APRIL 10, 2017
REPLACEMENT OF METRO-NORTH RAILROAD BRIDGE NO. 08012R
FEDERAL AID PROJECT NO. H121(002) & N/A
STATE PROJECT NOS. 135-301 & 301 - 163
CITY OF STAMFORD

ADDENDUM NO. 1

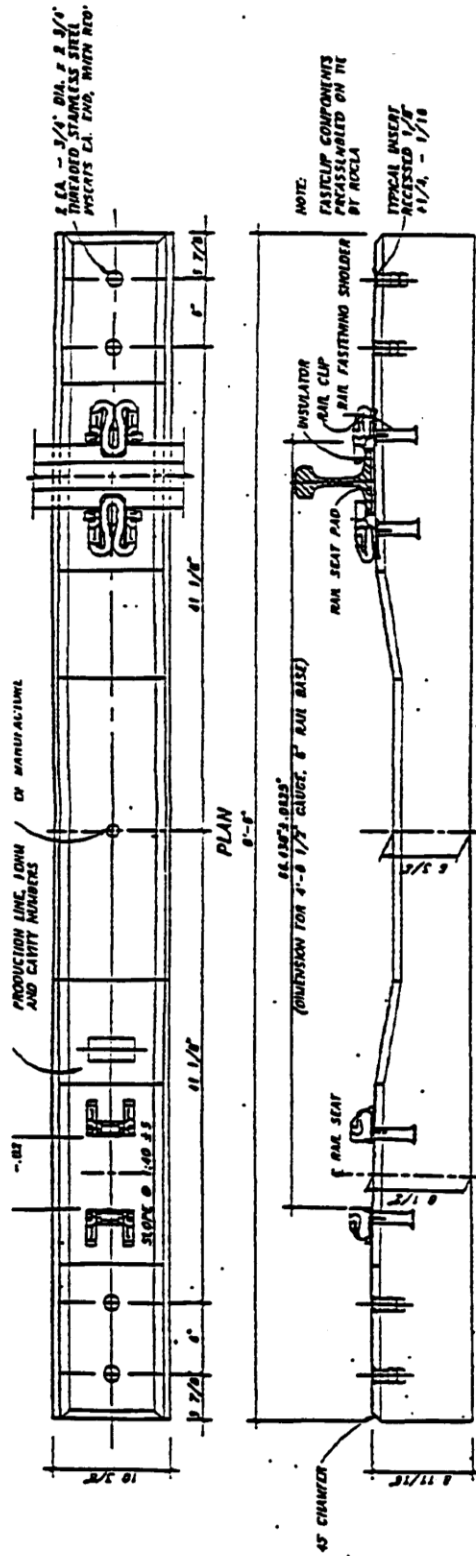
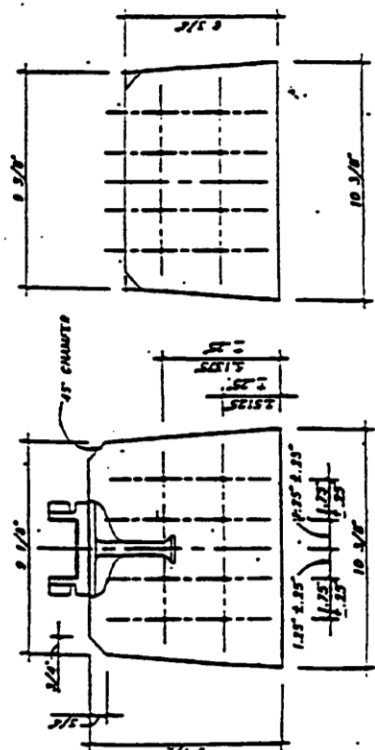
Field Panels: Must be full depth rubber panels with width to match Metro-North Standard Concrete Cross Tie (enclosed drawing). Panels must interlock and be capable of installation without use of lag screws.
